Evaluation of the Draft UNECE EVE Power Determination Test Procedure

Aaron Loiselle-Lapointe & Kieran Humphries
Emissions Research and Measurement Section
Environment and Climate Change Canada
335 River Road, Oshawa, ON
Canada

5. Section 6.9.4 Cont'd

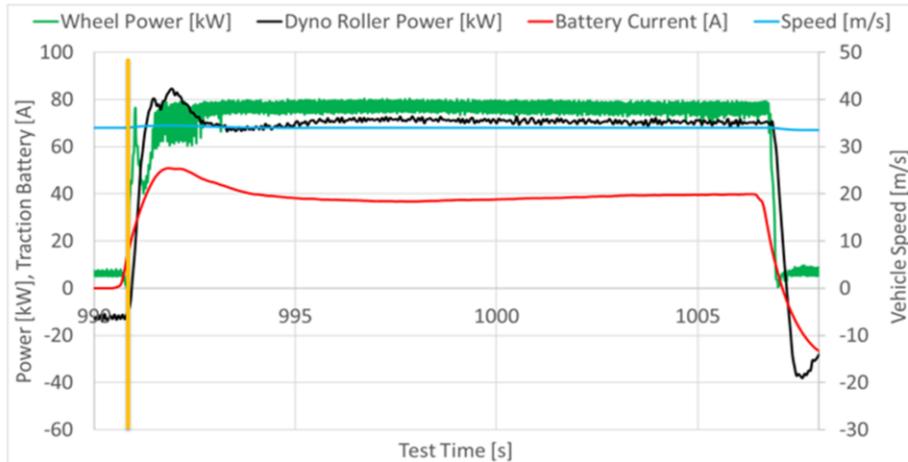
Section 6.10.1 states that the averaging function shall begin when the accelerator pedal command reaches 100%. In this example, that would be approximately here **[press button]**.

For hub-dynos this initial stabilization period would either be not present or much less pronounced. So, we were thinking, what provisions, if any are in the GTR that specify (1) the maximum stabilization period (2) the defining metrics for stabilization and (3) the magnitude allowed during this test. Does this provision already exist?
